CORRECTIVE MEASURES STUDY REPORT AREA OF CONCERN 633 (AOC 633) ZONE G
REVISION 1 CNC CHARLESTON SC
7/30/2004
CH2M HILL

AOC 633, Zone G

Re: Revision 1 replacement pages for *CMS Report, AOC 633, Zone G, Revision 0* –
Submitted on December 23, 2003

Figure 1-4
 Potentiometric Surface (without GW001)
 October 2002
 AOC 633, Zone G
 Charleston Naval Complex

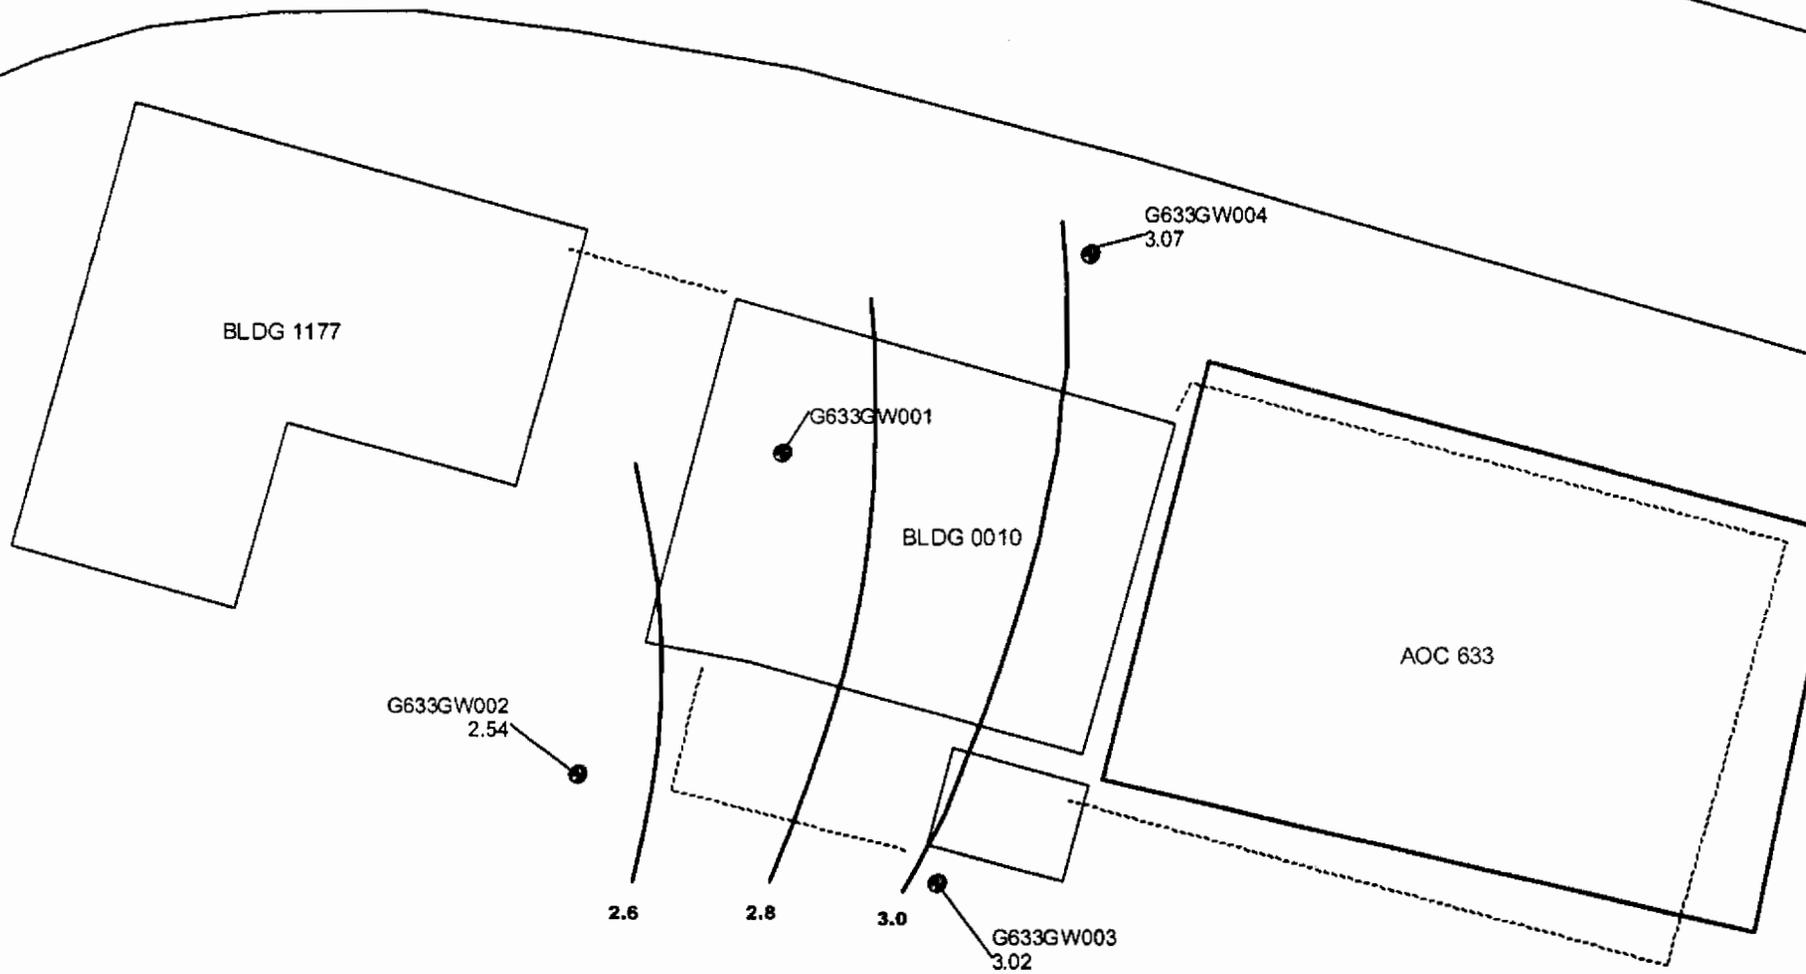
Monitoring well G633GW005 is absent from this figure. One must conclude that that water elevation from that well was not accounted for in the groundwater flow direction determination. The Navy must ensure that water elevations from all appropriate wells are accounted for in future groundwater flow determinations that are anticipated to be a part of the basewide groundwater monitoring program.

The groundwater contours shown in Figure 1-4 were measured in October 2002. Monitoring well G633GW005 was not installed until October 2003, so it was not available for the October 2002 monitoring event. The groundwater contours measured in October 2002, as shown in Figure 1-4, were used for selecting the location of monitoring well G633GW005 as a downgradient monitoring point, in consultation with Ms. Jo Cherie Overcash.

PROJECT NUMBER 158814	WELL NUMBER 633-MW-05	SHEET 1	OF 1
WELL COMPLETION DIAGRAM

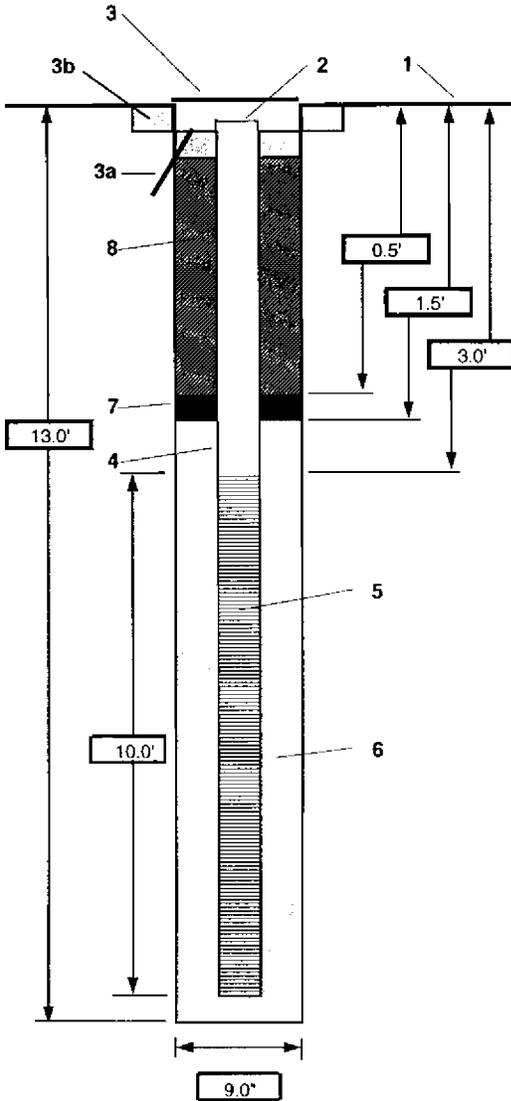
- a. There is a problem with the specifications for the concrete pad thickness, depth to top of the bentonite seal, and the grout thickness, as they relate to one another. Specifically, the pad is specified as extending 0.5 feet bgs, the top of the bentonite seal is also listed as 0.5 feet bgs. There is no room for the grout that is described as installed between these two components. Please verify the actual construction of this well, and revise the well completion diagram accordingly.

- b. This diagram specifies that bentonite chips were used for the seal. It should be noted that bentonite chips take longer to hydrate than pellets, and complete hydration is questionable. The hydration time that was used during construction of this well should be specified. This comment can be addressed informally, without a page revision. It is also recommended that bentonite pellets be used in the future.

- c. The well driller's name and certification number are not listed. Please revise to include this information.

The requested information and revised well construction log will be provided in the revised report. Based on a conversation with the field team leader, Darryl Gates, bentonite pellets are our
